ADDENDUM NO. 2
TO THE CONTRACT DOCUMENTS

Date: June 10, 2015
Project No.: 497074

CROSTOWN WATER TREATMENT PLANT IMPROVEMENTS BID #960-B
FAYETTE COUNTY WATER SYSTEM
FAYETTE COUNTY, GEORGIA

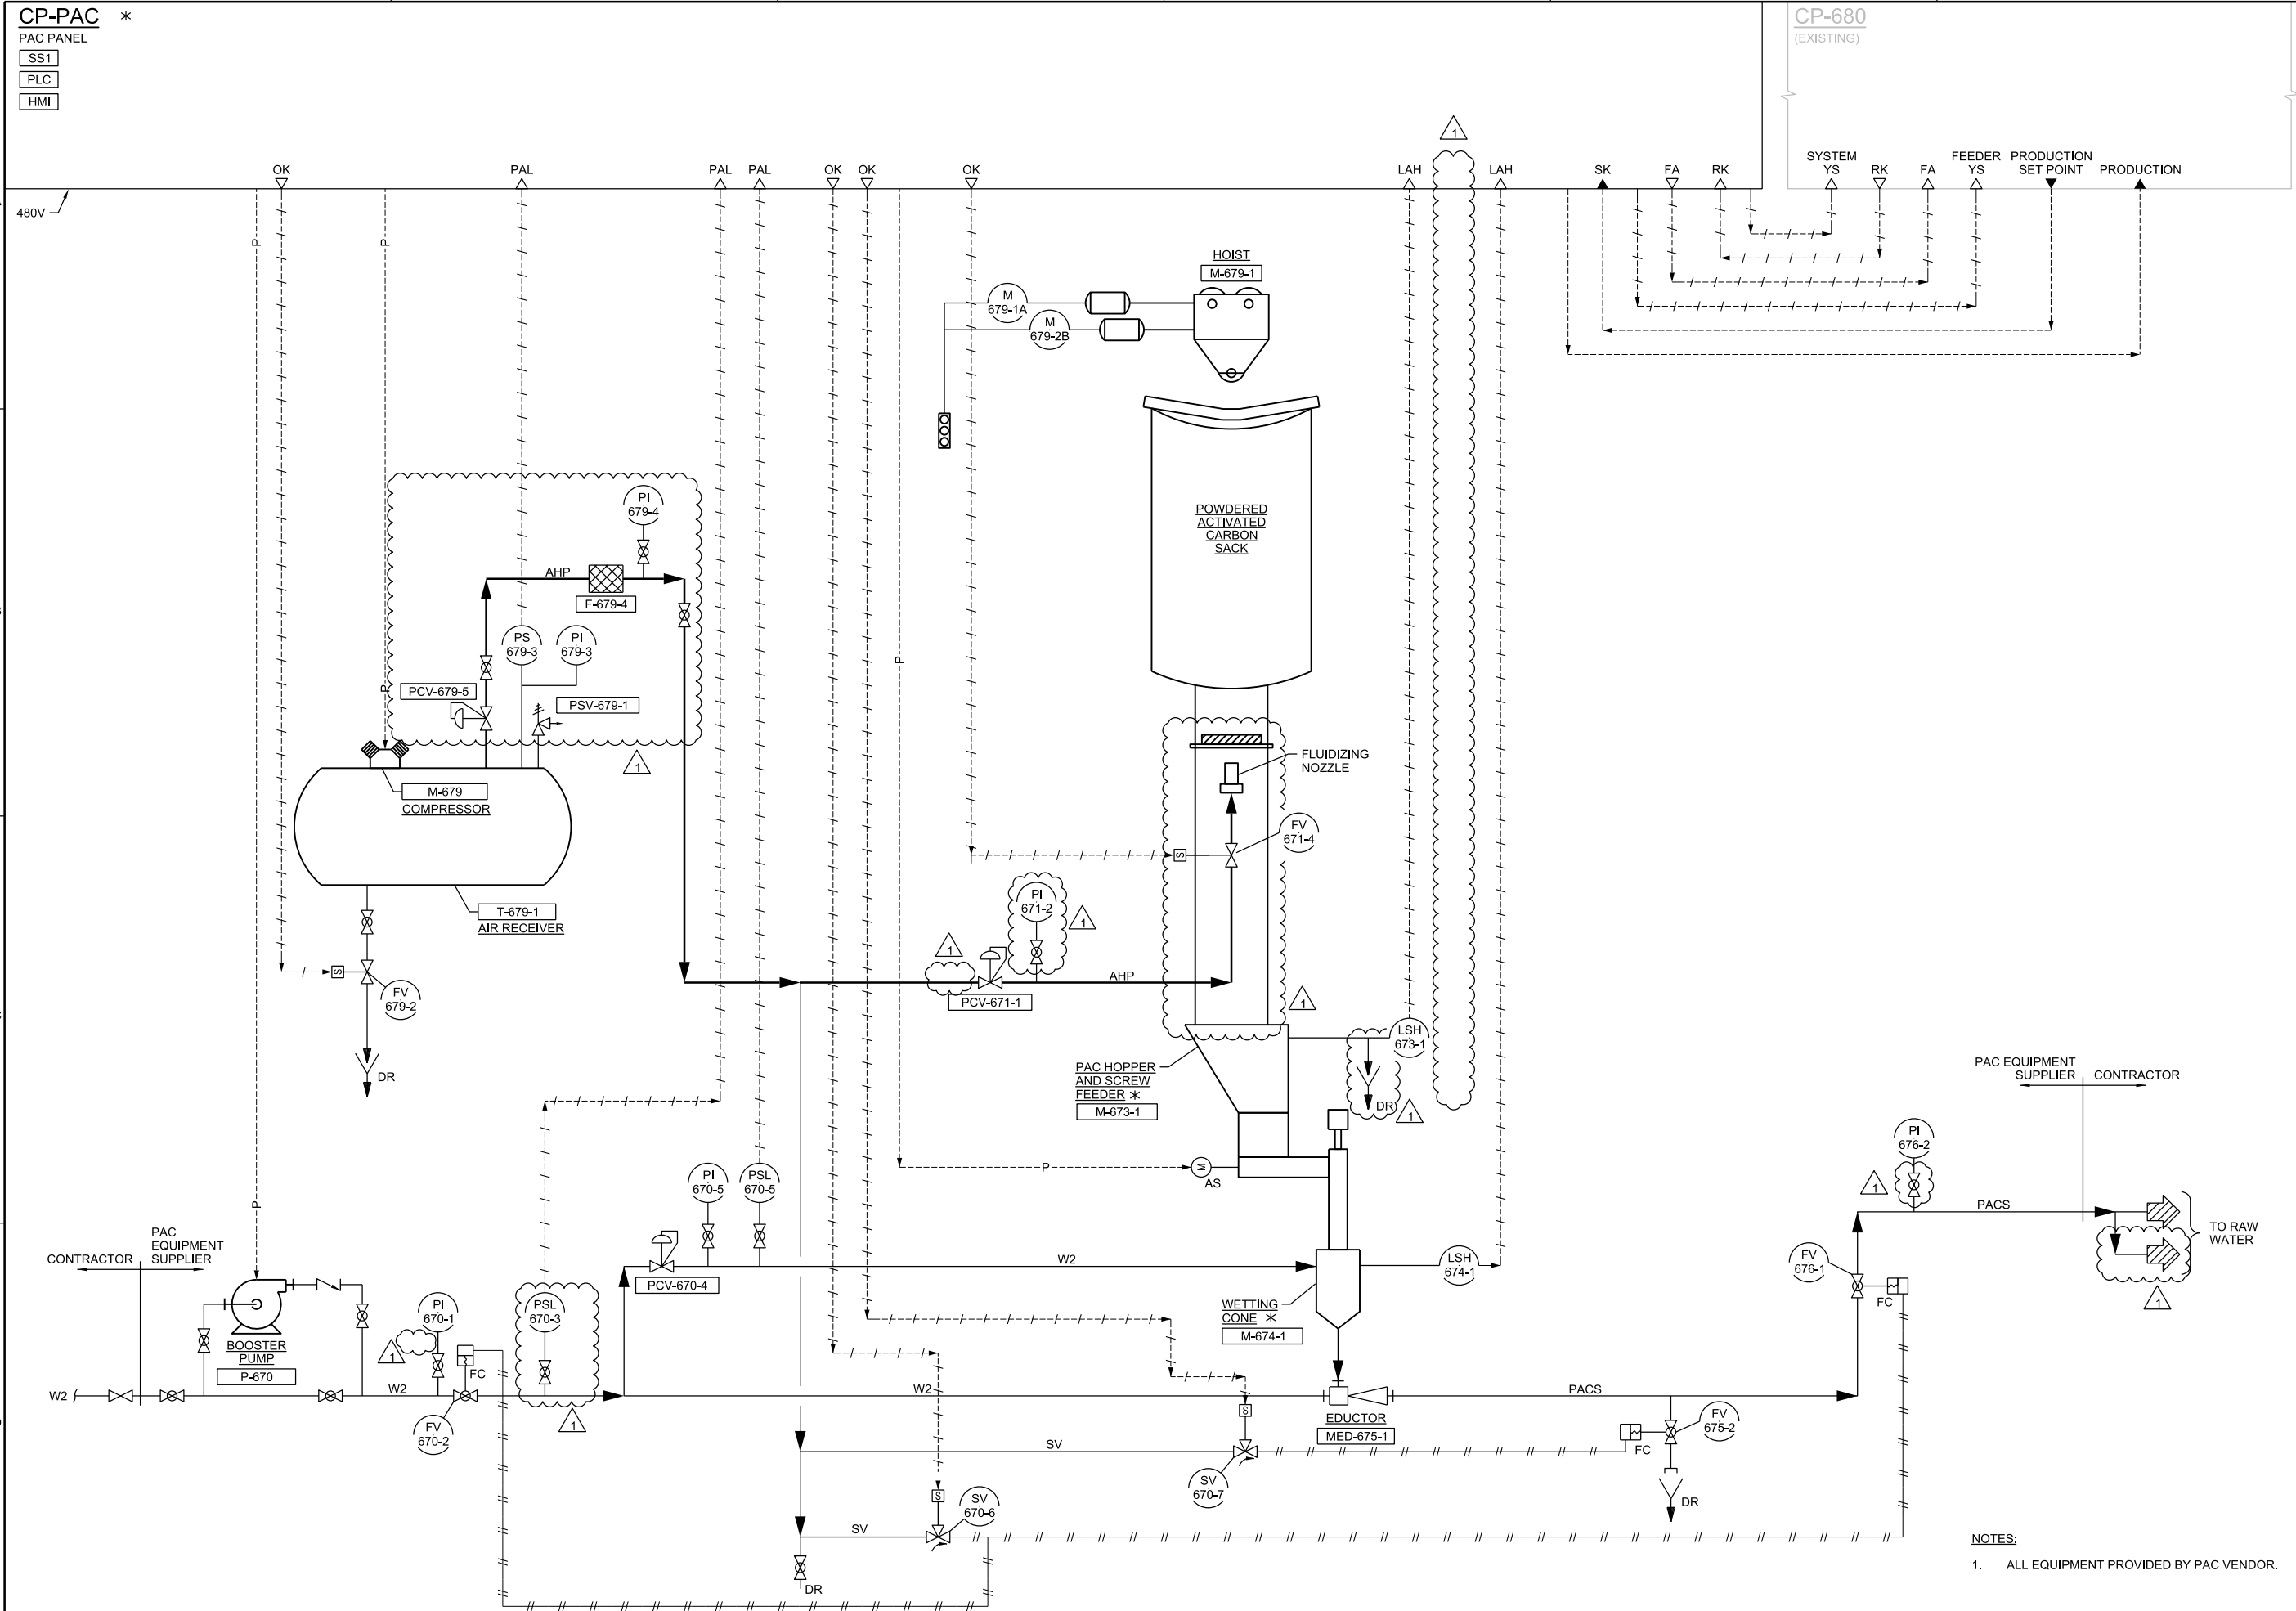
Q21. What type of pipe supports are required for the 1 ½" PAC Line and W2 lines shown on sheet 10-M-01?

A21. See 43 40 20-2.05.F.

I-01

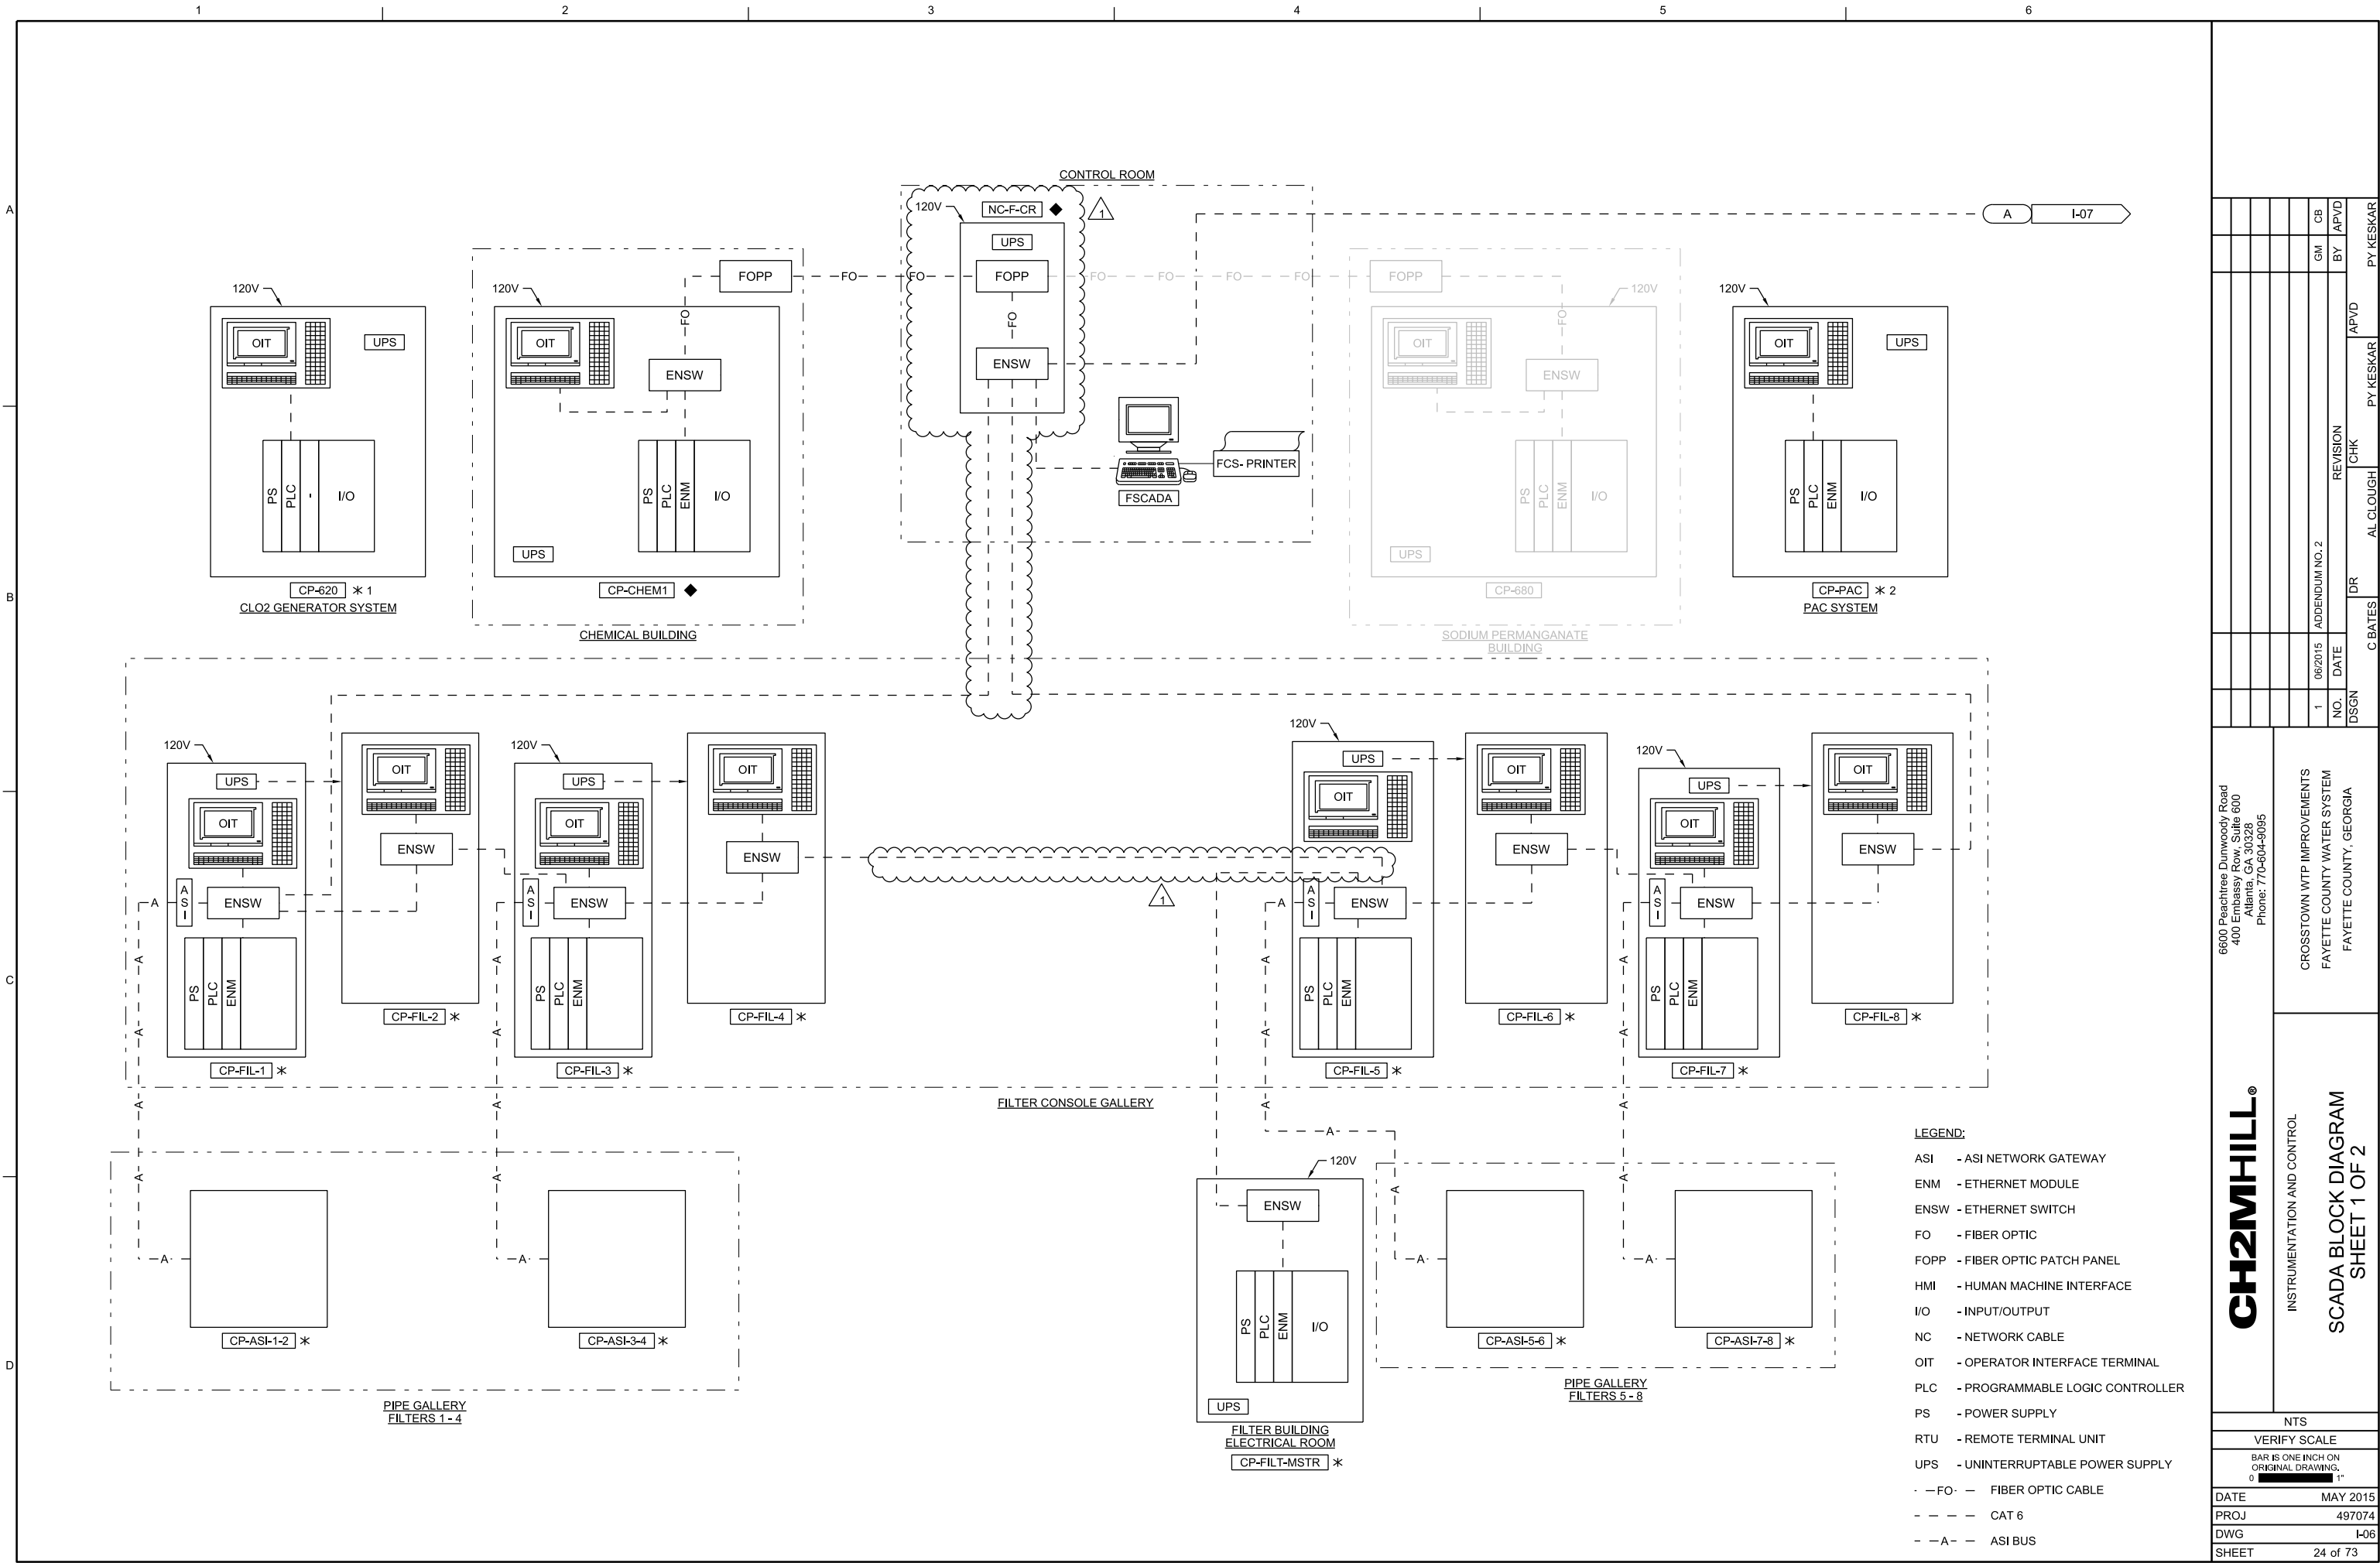
5. Drawing I-01, DELETE in its entirety and REPLACE with revised attached.
6. Drawing I-02, DELETE in its entirety and REPLACE with revised attached.
7. Drawing I-06, DELETE in its entirety and REPLACE with revised attached.
8. Drawing 20-M-03 grid locations 2B and 2D, REVISE depiction of truck delivery feed stations to match detail 4027-975X1.
9. Drawing 20-S-01 grid location 1A, DELETE “9’-0”” and REPLACE with “11’-0””
10. Drawing 30-M-01 grid location 3A, DELETE “4027-607A” and REPLACE with “4027-607”.
11. Drawing 30-M-02, at all four valves FV30X-4, DELETE depiction of RFAs.
12. Drawing 30-M-03 grid location 3A, DELETE “4027-607A” and REPLACE with “4027-607”.
13. Drawing 30-M-04

Q20. The Process Valves specification does not refer to FV-676-1, is this valve by the manufacturer of the PAC equipment?

A20. See Drawing I-01.

4091-206

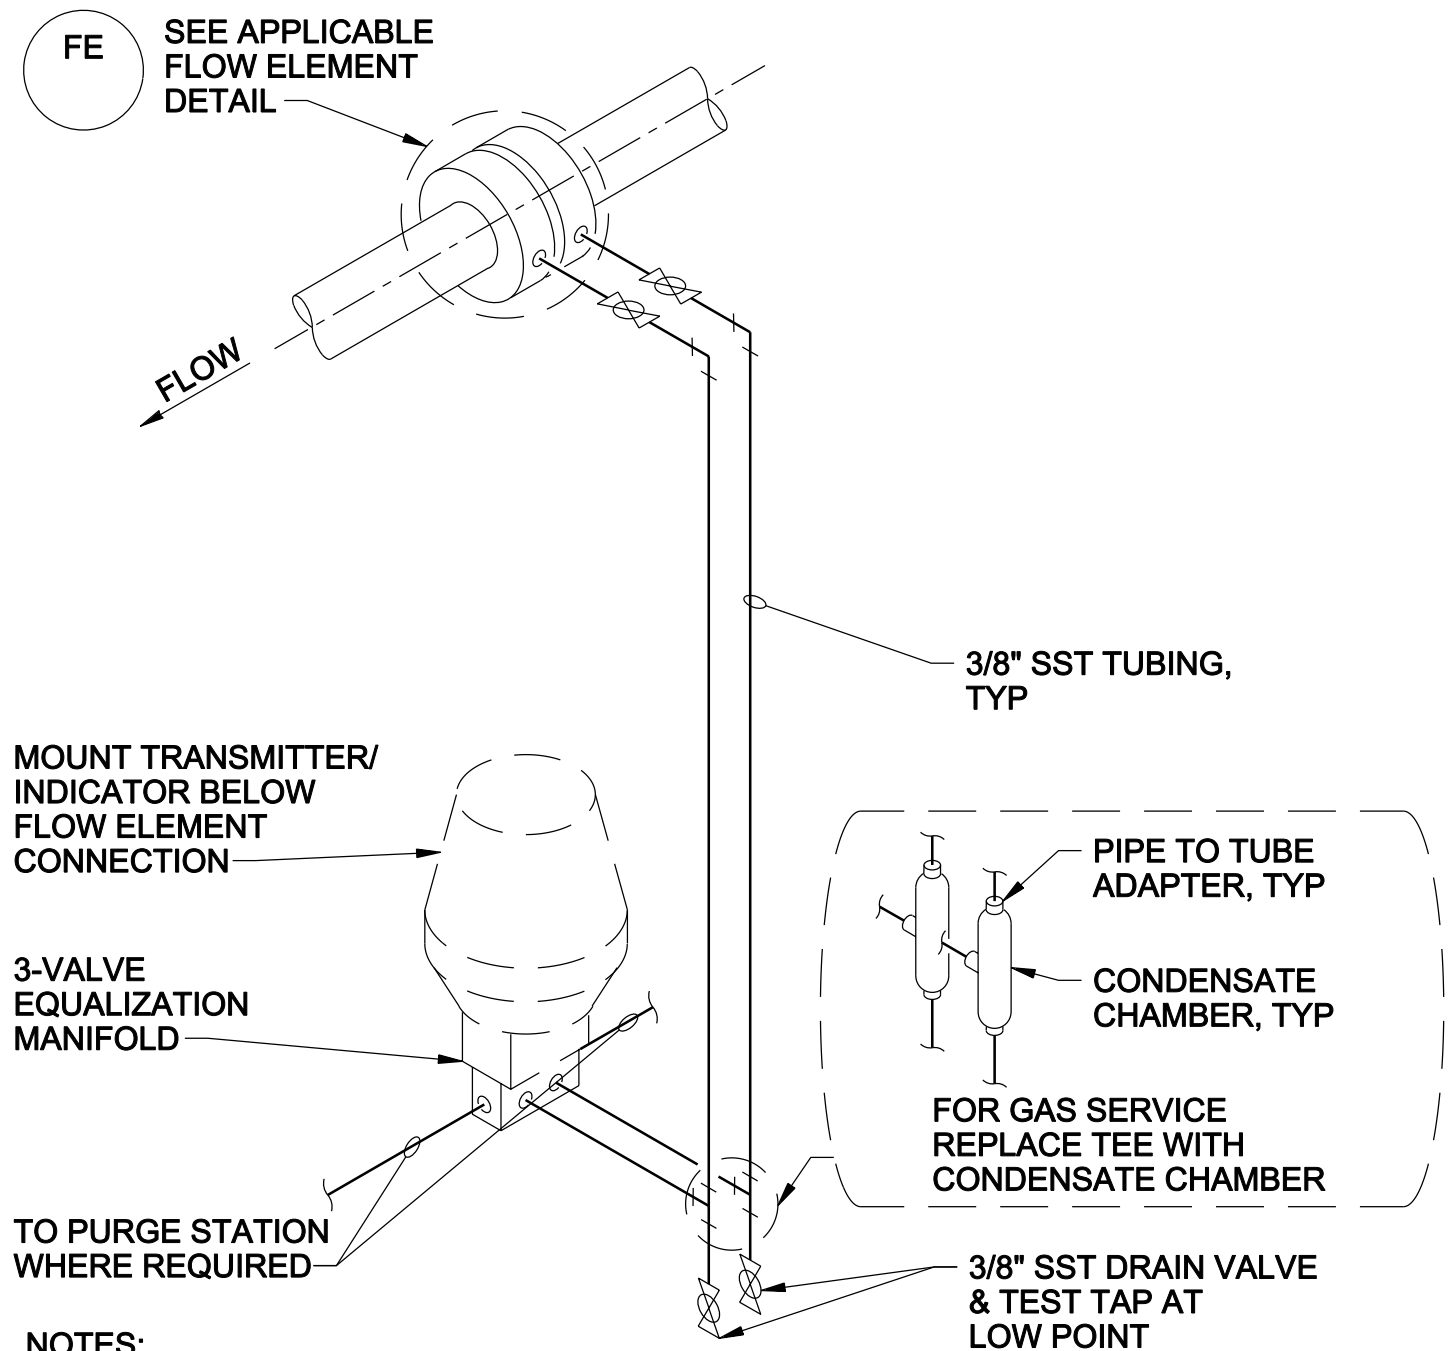
17. Drawing SD-09

DELETE Detail 4091-154G in its entirety.

ADD Detail 4091-206 PRESSURE DIFFERENTIAL
TRANSMITTER/INDICATOR FOR FLOW SERVICE attached.
